## Technical note:

# Chelmsford Local Plan Pre-Submission Document – Annex to the Landscape Sensitivity & Capacity Evidence Base Report: Corrections to Summary Tables

Figure 3.1 North East Chelmsford - Existing Landscape Capacity Gradings

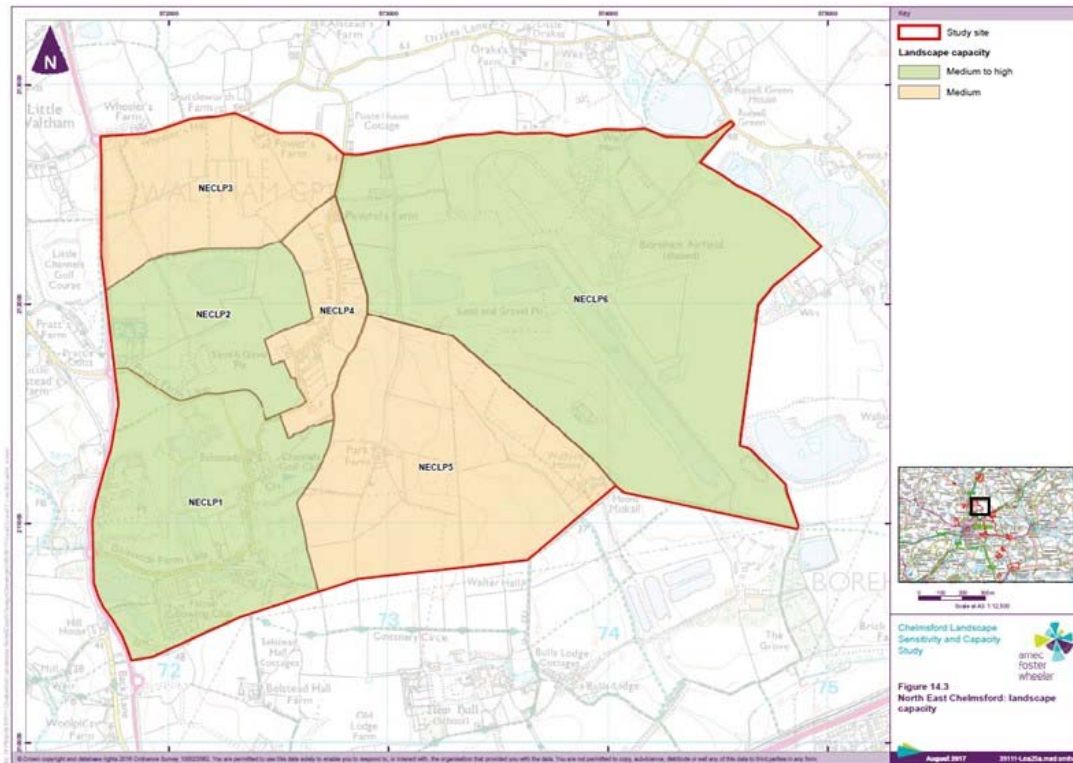
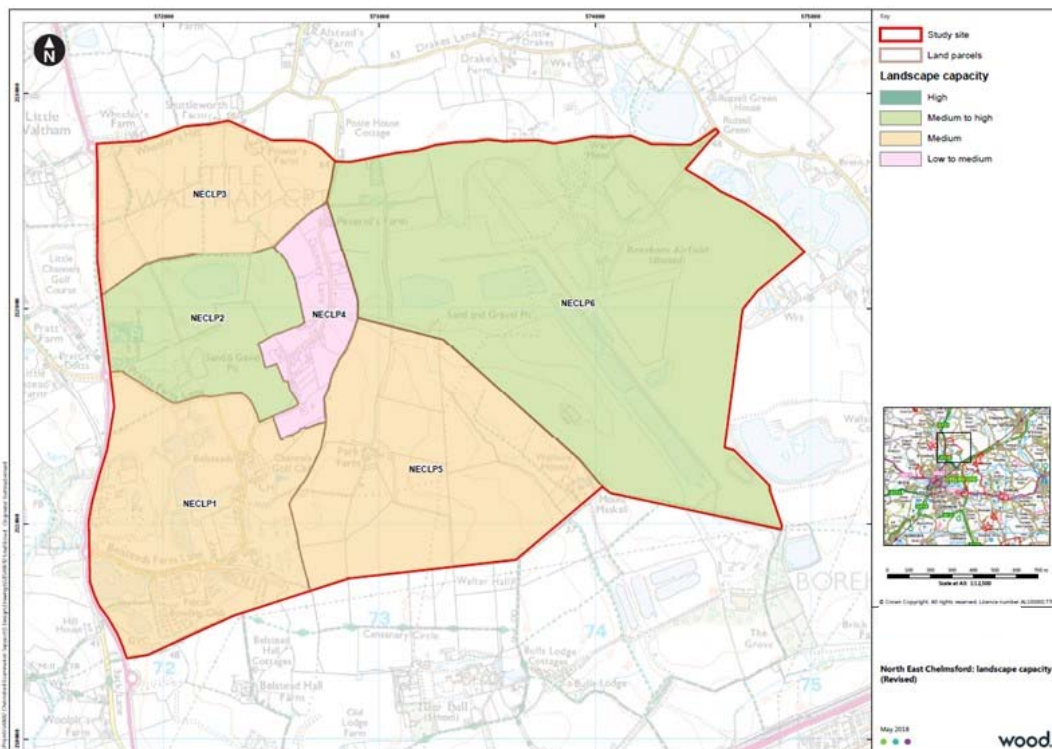
Land Parcel	Suggested Error by TOR	Response
<b>NECLP1</b>	Underestimation of landscape value – five scores of 'moderate' one of low, yet the overall landscape value is rated as low. The score should be moderate which would give a medium landscape capacity.	Agreed.
<b>NECLP2</b>	Underestimation of landscape character sensitivity – four scores of moderate, one of high and three of low yet the overall score for landscape is low. The landscape sensitivity should be moderate.	Disagree. The balance of landscape character sensitivity ratings should be: Low to Moderate. The overall Landscape Capacity should remain at: Medium to High.
<b>NECLP3</b>	The visual sensitivity and therefore the overall landscape sensitivity has been underestimated. The visual sensitivity should have scored on the higher side of moderate to high or at a minimum moderate to high. This would then give a low to medium capacity not a medium capacity.	Disagree. The Visual Sensitivity rating is Moderate to High, reflecting the parcel's elevated location. The overall Landscape Capacity should remain at Medium.

Land Parcel	Suggested Error by TOR	Response
<b>NECLP4</b>	The visual sensitivity and therefore overall landscape sensitivity has been underestimated. The visual sensitivity should have scored on the higher side of moderate to high based on two highs and a moderate. This would then give a low to medium capacity and not a medium capacity.	Agreed.
<b>NECLP5</b>	The visual sensitivity and therefore overall landscape sensitivity has been underestimated. The visual sensitivity should have scored on the higher side of moderate to high making the overall landscape sensitivity high or at a minimum moderate to high. This would then give a low to medium capacity not a medium capacity.	Disagree. Whilst the landscape is open, with middle and longer distance views available, there are few receptors and potential for mitigation. The overall landscape sensitivity remains at Moderate and the Landscape Capacity at Medium.

The changes to the summary ratings are illustrated in Figure 3.1 and Figure 3.2.
